Subject: FW: AL/67/25/PL Nyton Rest

Subject: RE: AL/67/25/PL Nyton Rest - Suggested Planning Conditions

Subject: FW: AL/67/25/PL Nyton Rest - Suggested Planning Conditions

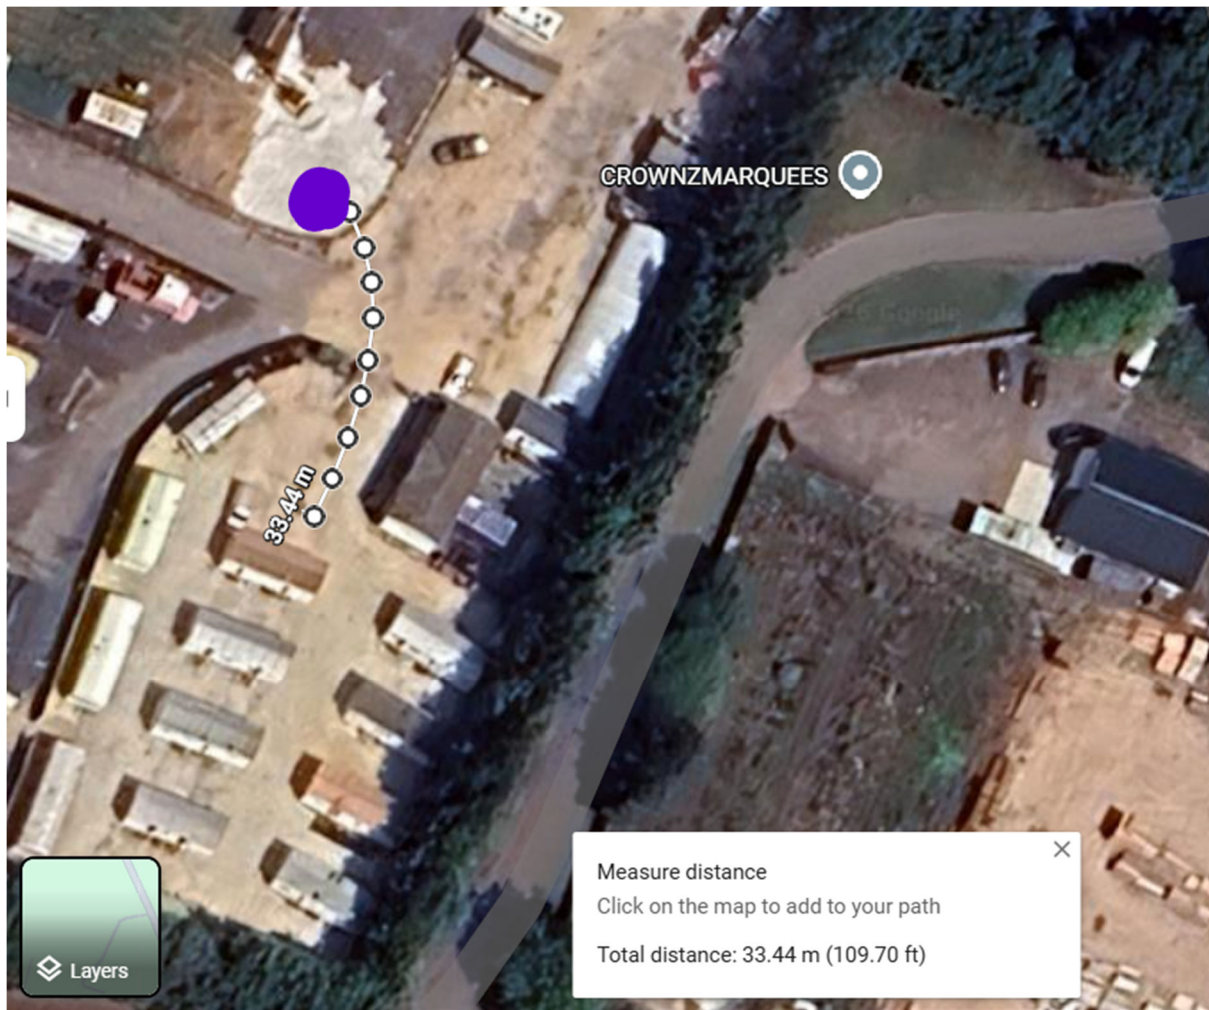
I write further to your email of 12/02/2026. I have now been provided with the email below and the plan attached. Does this demonstrate the requested hose lay route?

The first satellite image below shows that the allocated location for the fire appliance within the application site can provide water to all caravans on site including those furthest away within a distance of 45m. The furthest caravan shown on the image below is 42m approximately. The preferred position for the fire appliance is shown with a white rectangle on the attached.

The second image below shows that with a water release valve for fighting purposes located on the eastern side of that tank (at approximately 3 O Clock) an almost straight line can be drawn from that point on the tank to the location where the fire appliance would be stationed as shown on the attached plan. That distance measured off Google Earth would be 33.44m from tank water release valve to fire appliance. That line can be drawn relatively straight because there is no field boundary at the location of the tank and there is also an open gate that can be used to bring the hose through. In other words there are no obstacles in the path in the proposed route of the hose.

Providing the additional details provide for this planning application are implemented, the requirements identified in the planning consultation will be met and no further action required. I would request West Sussex Fire & Rescue Service are informed when the water tank is in place and ready for use, so we can add it to our operational mapping and visit the site to mark up the location to make it clear to attending fire crews where the supply of water for firefighting is located.
